**WYOMING  
GROUNDWATER, LLC**

November 15, 2017

**Re: Technical Review of *Site Specific Investigation Report: Eastridge Subdivision, Lot 16, October 27, 2017; Trihydro Corporation***

**Figure 1-1 - Location Map**  
**Laramie Monitor Well Project**

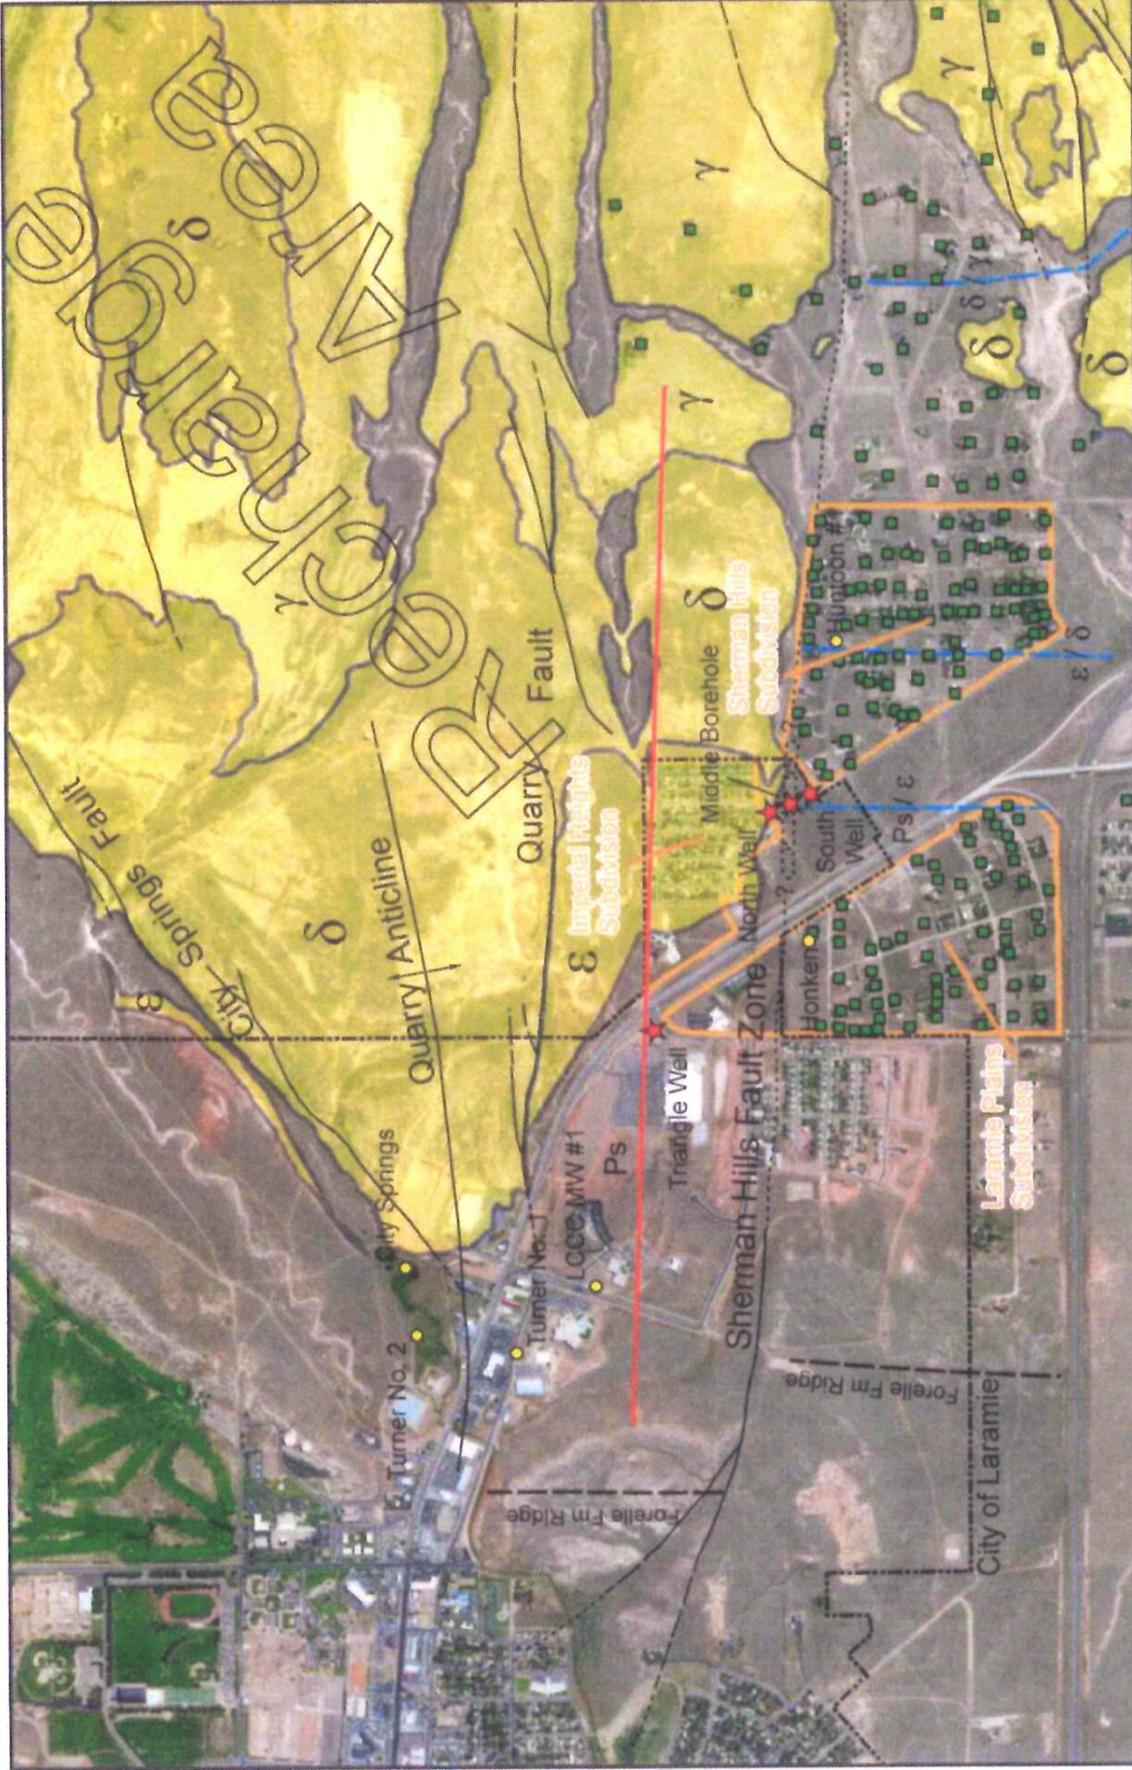
Much has been learned about the Sherman Hills Fault as a result of installing and testing three monitoring wells across the fault at Imperial Heights Park (Phase II – Laramie Monitor Well Project Report (LMWPR), City of Laramie, June 2015). Figure 1-1 from the LMWPR is attached which shows the location of the three monitoring wells, Sherman Hills Fault, and the subject property located beneath the word “Fault” on the figure. At Imperial Heights Park, the Sherman Hills Fault has the following characteristics:

- Total vertical displacement across the fault is 39 feet (up on north side, down on south side);
- Displacement does not occur across a single fault, but rather across a 250 to 300 feet wide “fault zone” consisting of multiple faults; and

- Fractures occur in the Casper Formation in the fault zone and are responsible for high permeability in the aquifer.

These observations represent the best available information regarding the Sherman Hills Fault and should have been integrated into the evaluation of hydrogeologic conditions at the subject property. For example, the mapped fault trace should be viewed as the center of a fault zone that is 250 to 300 feet wide such that it is reasonable to suspect that fractured conditions (i.e. “disturbed” strata) occur in the Satanka Shale and Casper Aquifer over the southern 2/3 of the subject property. These observations, in combination with Comment #3 to follow, provide justification to modify SSI reason #5 in the SSI report conclusions sections (listed previously).

Trihydro estimates that the thickness of the Satanka Shale on the subject property is approximately 80 feet. This value was calculated using a stratigraphic dip of 3 degrees across a distance of 2,900 feet eastward from the subject property to the Casper outcrop. The distance of 2,900 feet used Trihydro's calculation is incorrect for two reasons: First, the distance used should reflect the Satanka-Casper contact, rather than the first surface exposure of the Casper. The 2,900 feet reflects the contact where alluvium overlies the lower part of the epsilon member of the Casper. Second, in this area, Ver Ploeg's (2009) map showing Satanka Shale and Casper epsilon member exposures is incorrect. The Laramie Monitor Well Project Report (Hinckley and Moody, 2015) rectified map inaccuracies by redefining the Satanka-Casper contact as controlled by well data and surface exposures (see attached Figure 1-1).

Using the epsilon member-Satanka shale contact shown on Figure 1-1, the distance from the center of the subject property to the contact is 2,180 feet. Using a stratigraphic dip of 3 degrees minus a ground elevation difference of 50 feet between the contact and the subject property, a calculated thickness of the Satanka Shale on the north side of the fault in the center of the subject property is approximately 64 feet. Assuming an average value of 9 feet for the thickness of the alluvium in the area of the Sherman Hills Fault (Table 1), the approximate thickness of the Satanka Shale in the center of the subject property

may actually be 55 feet (i.e. slightly thicker at the west edge and slightly thinner at the east edge of the subject property).

Based on this analysis and recalculation, the thickness of the Satanka Shale at the subject property is probably less than Trihydro's calculated 80 feet and less than the 75 feet of "undisturbed" Satanka Shale used in the Casper Aquifer Protection Plan (CAPP) to indicate adequate physical protection of the underlying Casper Aquifer. This discussion of the thickness of the Satanka Shale, and whether or not the thickness equals or exceeds 75 feet, is rendered somewhat irrelevant because it is reasonable to suspect that the Satanka Shale is "disturbed" by deformation and fractures within the Sherman Hills Fault Zone which occupies the southern 2/3 of the subject property. On both counts – thickness value and likelihood of being disturbed – it is reasonable to conclude that the Satanka Shale will not, per CAPP criteria, provide adequate physical protection to the underlying Casper Aquifer at the subject property.
